**KROC COMMUNITY CENTER
ENVIRONMENTAL IMPACT REPORT**

**VOLUME III
FINAL ENVIRONMENTAL IMPACT REPORT**

SECTIONS	PAGE
12.0 CLARIFICATIONS AND REVISIONS TO THE DRAFT ENVIRONMENTAL IMPACT REPORT	12-1
13.0 RESPONSE TO COMMENTS ON DRAFT ENVIRONMENTAL IMPACT REPORT	13-1
13.1 Summary Distribution List/Respondents	13-1
13.1.1 Federal Agencies	13-1
13.1.2 State Agencies	13-1
13.1.3 Regional Agencies	13-1
13.1.4 County Agencies	13-2
13.1.5 Local Agencies	13-2
13.1.6 Private Organizations	13-2
13.1.7 Individuals.....	13-2
13.2 Letters of Comment and Responses.....	13-3
13.2.1 Federal Agencies	13-4
13.2.2 State Agencies	13-5
13.2.3 Regional Agencies	13-7
13.2.4 County Agency.....	13-9
13.2.5 Local Agencies	13-14
13.2.6 Private Organizations	13-37
13.2.7 Individuals.....	13-38

FIGURE R.2.1-4
Aerial Photograph

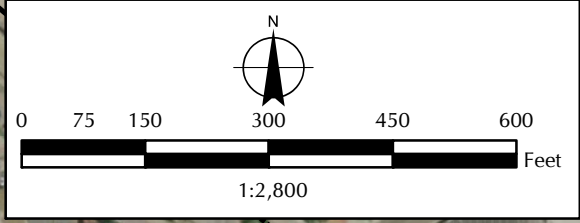
Page 2-1 Please replace Figure 2.1-4, *Aerial Photograph*, with Figure R.2.1-4, *Aerial Photograph*, which has been revised to reflect the City of Signal Hill zoning map boundaries that place the City boundaries north of the bins.

- **Page 2-3. Section 2.2.4. Existing Site Facilities** states that the parcel “is bounded by a flood control area to the north.” This is incorrect, as is the aerial photograph in Figure 2.2.4-1, Neighboring Land Uses. Page 3.6-6 correctly identifies the site as a future middle school site. The statement in section 2.2.4 and Figure 2.2.4-1 should be corrected.

Thank you for the comment. It has been noted that the Figure 2.1-4, *Aerial Photograph*, should be revised to show the storage property as entirely within the City of Long Beach boundary. The property north of the proposed project boundary (which also serves as a flood control area) contains privately owned and operated storage parcels. These parcels are not and would not be included in the proposed project. Figure R.2.1-4, *Aerial Photograph*, has been revised to reflect the information on the City of Signal Hill zoning map that places the City boundaries north of the bins. The revised figure is provided in Section 12.0.

FIGURE R.2.2.4-1
Surrounding Land Uses

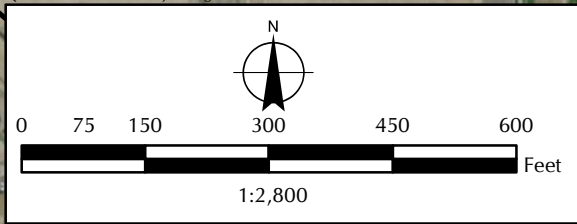
Page 2-3 Please replace Figure 2.2.4-1, *Neighboring Land Uses*, with Figure R.2.2.4-1, *Surrounding Land Uses*, which has been revised to illustrate that the land use of the property northeast of the proposed project site is light industrial.

Neighboring Land Uses: Figure 2.2.4-1, *Neighboring Land Uses*, has been revised to illustrate that the land use of the City of Signal Hill property northeast of the proposed project site is light industrial. The name of Figure 2.2.4-1, *Neighboring Land Uses* has been changed to Figure R.2.2.4-1, *Surrounding Land Uses*, and is provided in Section 12.0.

FIGURE 2.6.3-1
Kroc Community Center Grading Plan

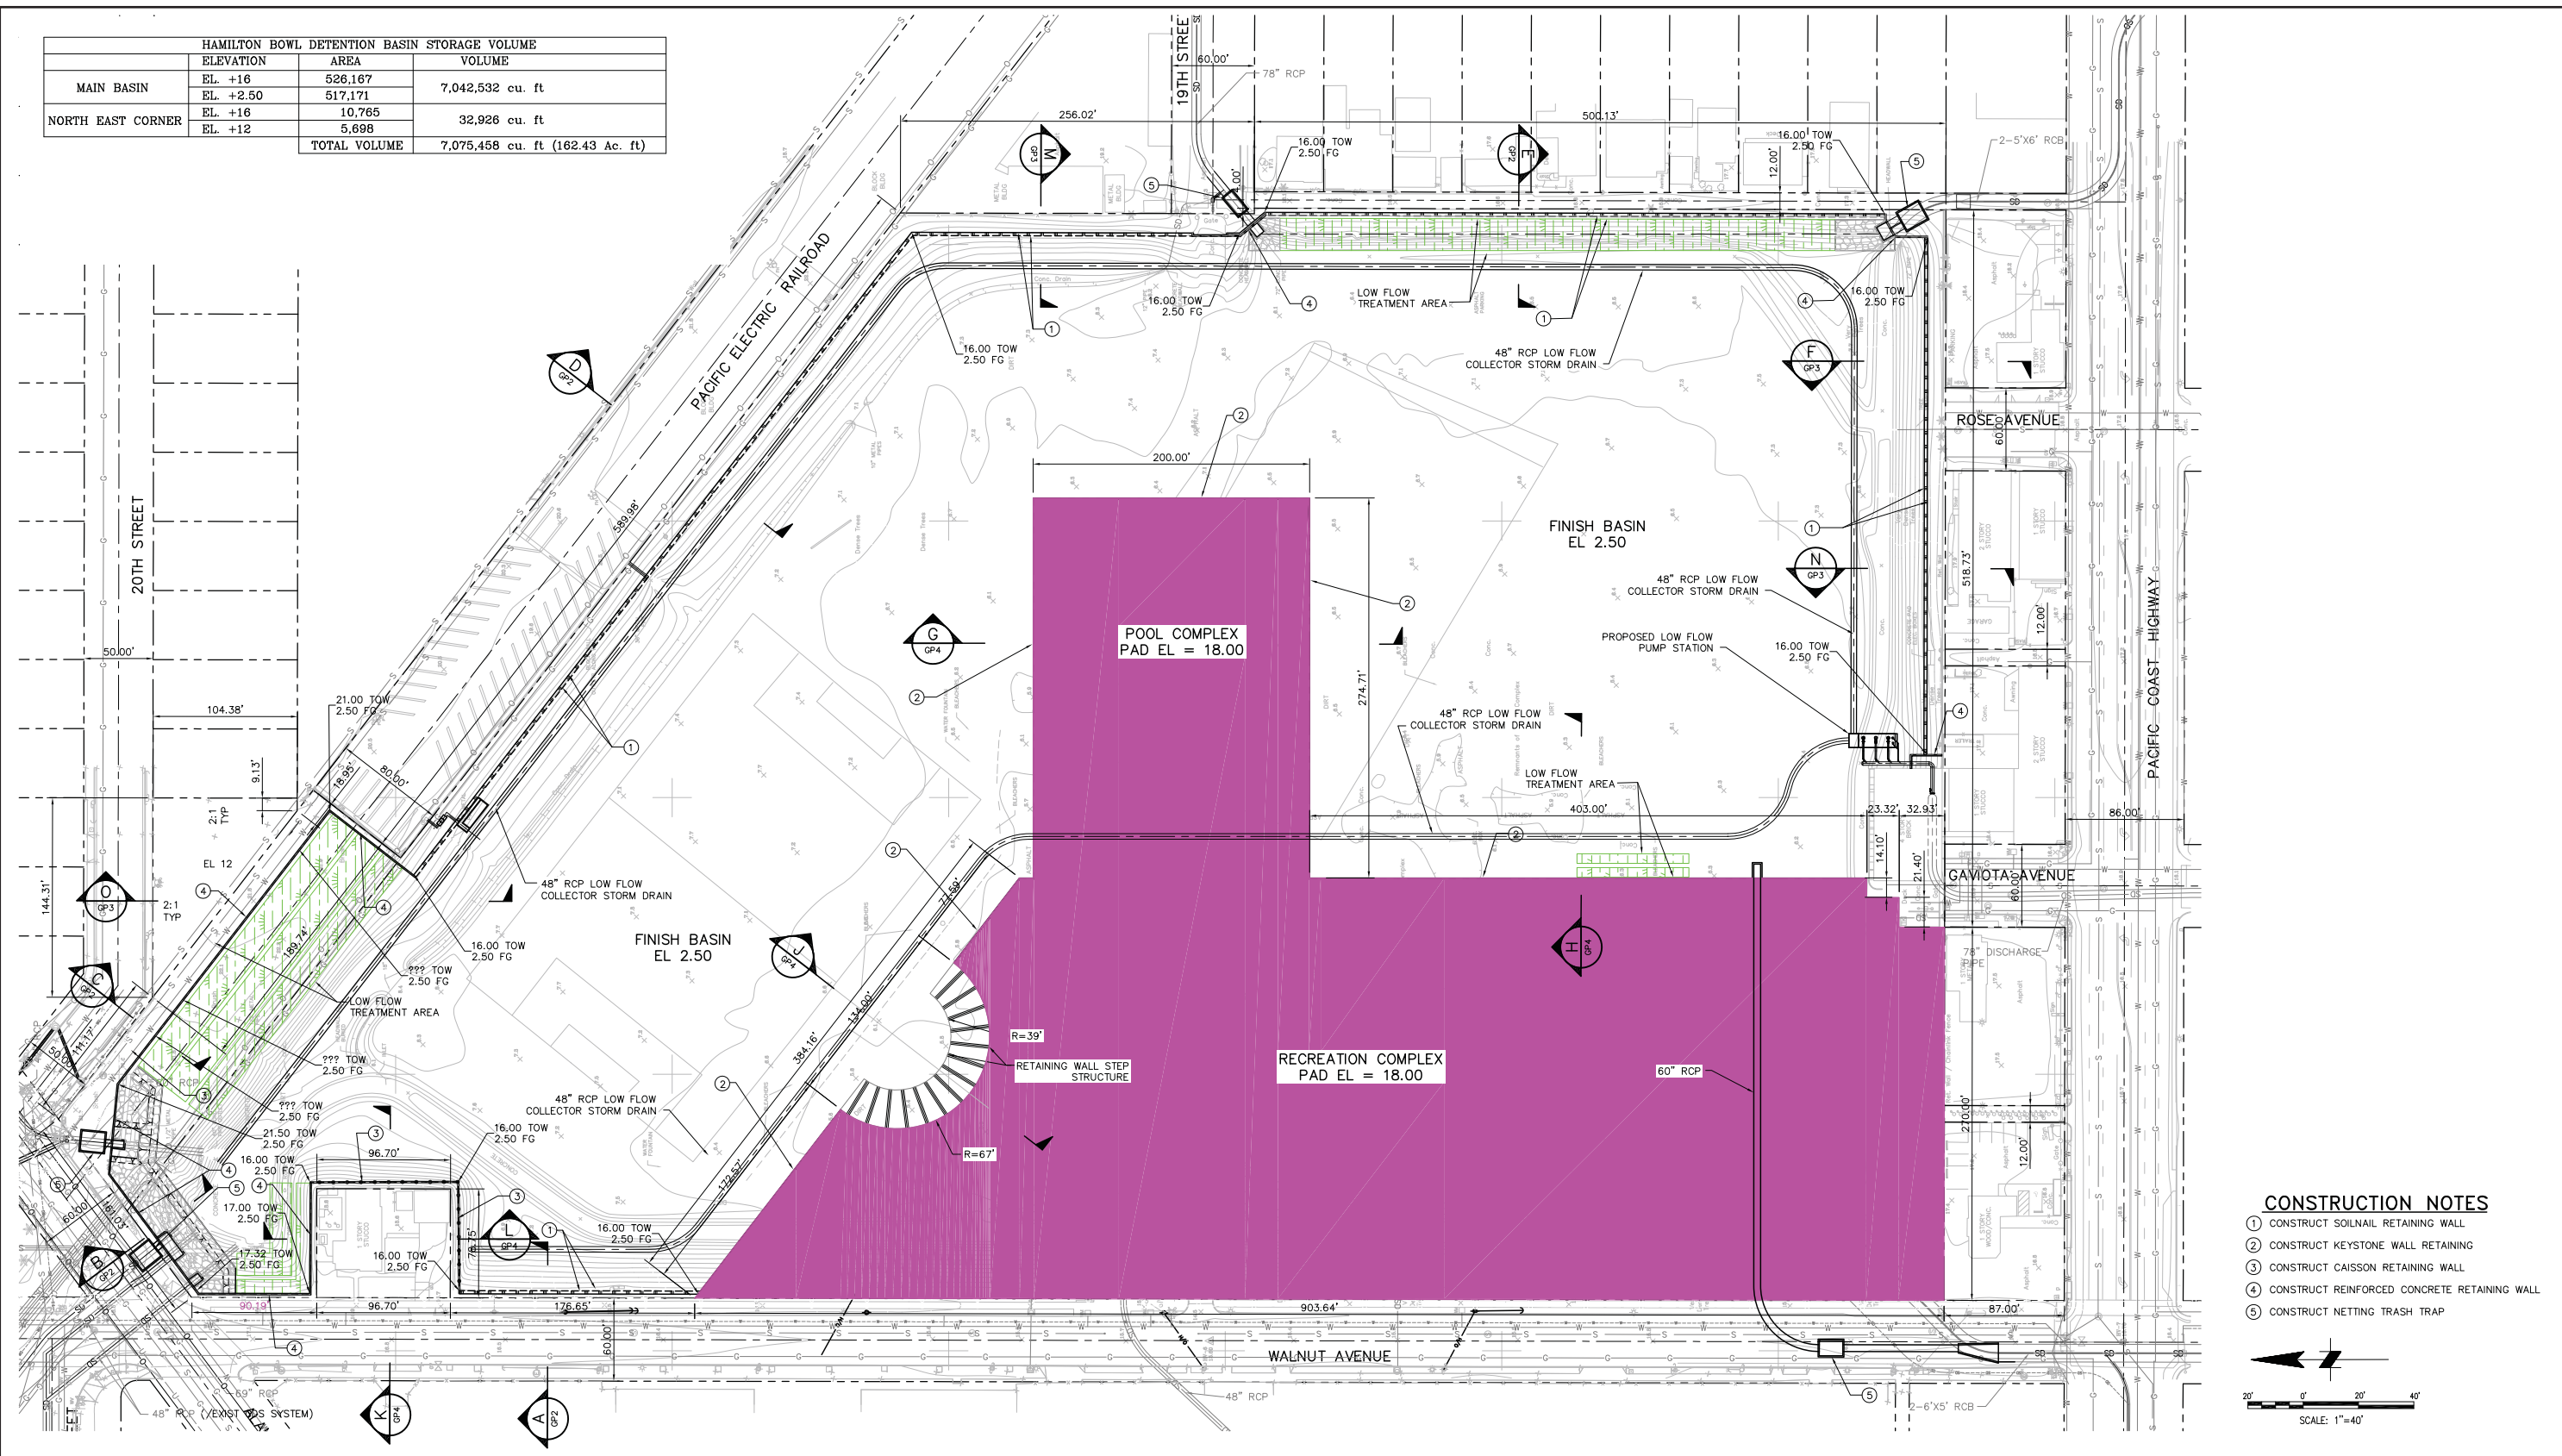
3. Section 2.6.3: Currently, the information provided to Public Works, including the site plan and the Preliminary Conceptual Level Detention Basin Analysis, provides only general information and is inadequate for design purposes or the determination of the proposed development impact on the hydrology. The project developer will be required to submit improvement plans for review and approval | 3

As specified in a letter from the City of Long Beach to the City of Signal Hill,⁷ the applicant shall be required to complete construction, grading, and improvements to the flood control and water quality control facilities related to the Hamilton Bowl Detention Basin in a manner that ensures that there is no net loss or compromise of the existing flood detention capacity or water quality during construction or operation of the proposed (Figure 2.6.3-1, *Kroc Community Center Grading Plan*):
